Q&A Follow-up Information

ICO Creekside – Cottonwood Heights

August 2018

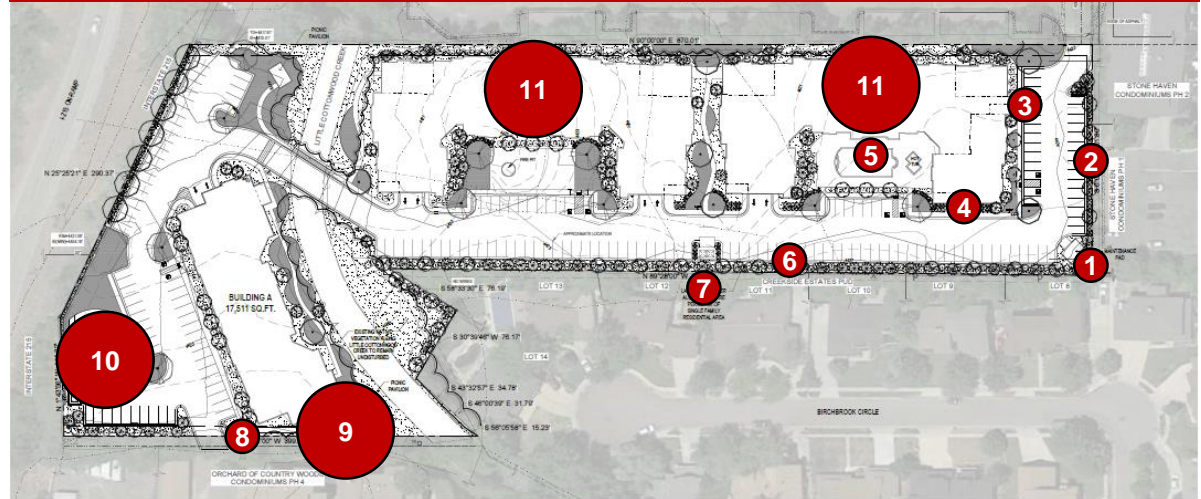
- ICO held three community workshops to ensure neighboring residents could provide input. In response to feedback from both Cottonwood Heights City and residents in the communities surrounding the proposed development, eleven significant adjustments, all to benefit adjacent land owners and at significant cost to the developer, have been made to the original development plan and landscaping designs. The images below set forth the “before” and “after” landscaping plan, with changes highlighted:

- 1 Doubled densely vegetated buffer from 10' to 20' to provide single family homes more privacy
- 2 Upgraded fencing material from see-through wrought iron to 6' solid vinyl

- 3 Added planter boxes to front façade of building to enhance feel of separation from front parking spaces
- 4 Decreased wing length of buildings A & B to increase setback from single family homes to provide more privacy

- 5 Increased vegetation between pool and parking to provide sound buffer; also enhanced landscaping in Building B courtyard for additional sound dampening

- 6 Changed plant selection to include blue spruce for year-round privacy along back yard fences for single family neighbors; 30-50' mature height
- 7 Moved garbage dumpster from middle of south parking area to west end of south parking to reduce potential dumpster noise

- 8 Added blue spruce along south property line shared with Orchard of Country Woods to enhance privacy for condo building to the south
- 9 Redesigned Building C to increase setback by 150% to enhance privacy of multi-family neighbors in condos to the south

- 10 Added full emergency vehicle turnaround
- 11 Proposed increased sprinkler and water access density for fire teams to enhance resident safety

Setback Detail – Orchard of Country Woods

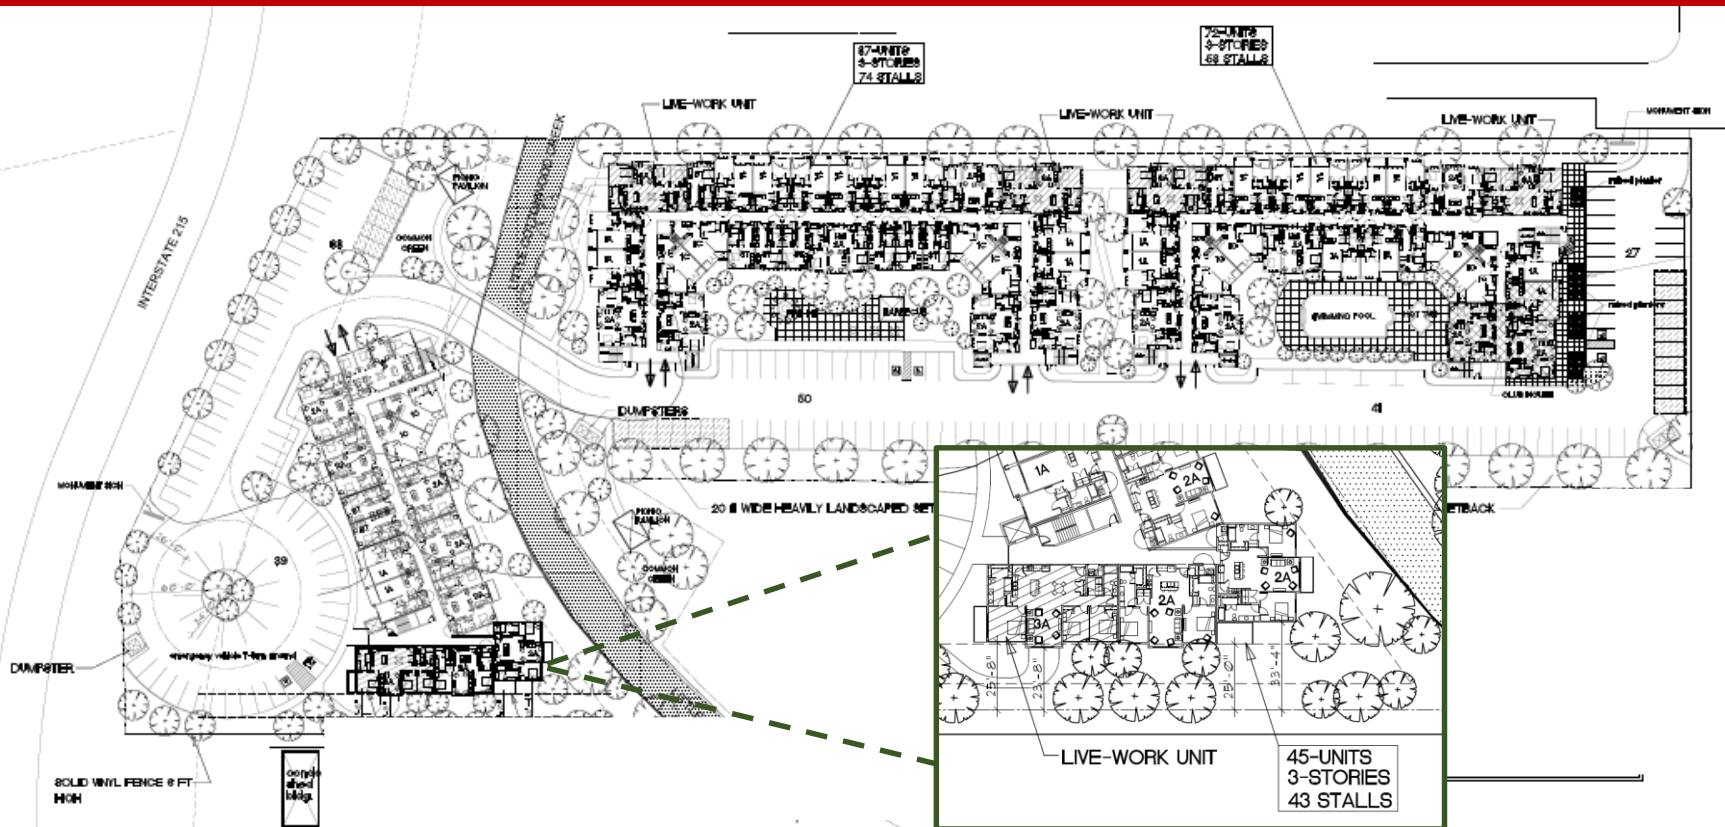
SITE PLAN UPDATE – BUILDING C (CHANGE ITEM #9)

- In the previous Planning Commission session, ICO was asked to re-evaluate Building C to see if setbacks or building height could be adjusted to accommodate condo owners and renters in the neighboring multi-family community.
- After in-depth review of potential options, ICO ultimately engaged its architect to redesign Building C. Previously ICO had placed Building C at the minimum zoning setback of 10', and focused more on setbacks to single family neighbors.
 - The south end of Building C is now square with The Orchard of Country Woods' property line with a set back of >25' on average, a 150% increase from the previous proposal.
 - The new proposed setback averages >25', and when combined with the title gap of 9'-12' and the 12' setback of the existing Orchard's buildings, equates to an average separation between buildings of 47'.

Turnaround Only (Most Likely Outcome)

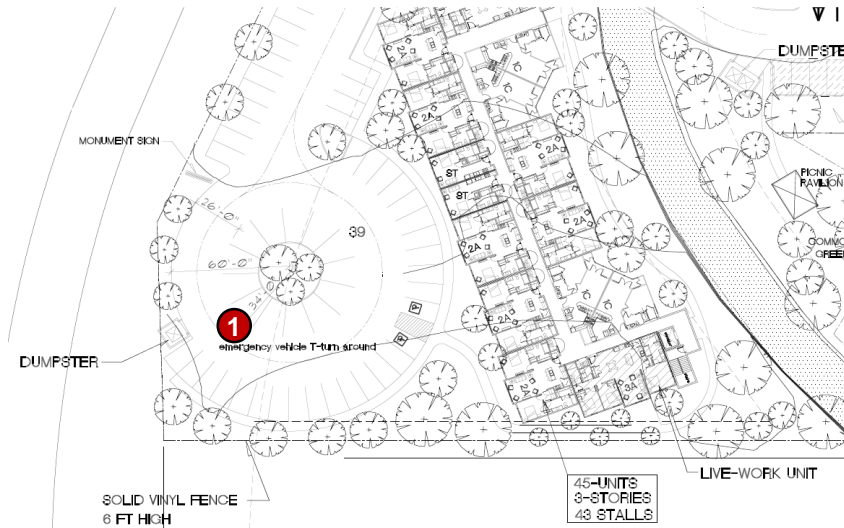
FIRE UPDATE FOLLOWING CBPE REPORT (CHANGE ITEMS #10 & #11)

- CBPE, Inc. produced a report recommending that with modest site plan adjustments, ICO's proposed site plan would meet fire code. As highlighted previously, the suggested changes include:
 - A full NFPA 13 fire system
 - Increased stand pipe density along the corridor spanning buildings A and B
 - Increased hydrant density along the corridor spanning buildings A and B
- As illustrated previously, the updated site plan reflects these changes with and include an emergency vehicle turnaround

- 1 Full width turnaround loop for emergency vehicles
- 2 Secondary emergency access

- Despite ICO's best efforts to reach an agreement with the Orchard of Country Woods, it appears that the most likely path forward is to exclude the secondary emergency exit. As noted in the CBPE fire engineer report, the addition of the emergency turnaround precludes any requirements for a secondary access.
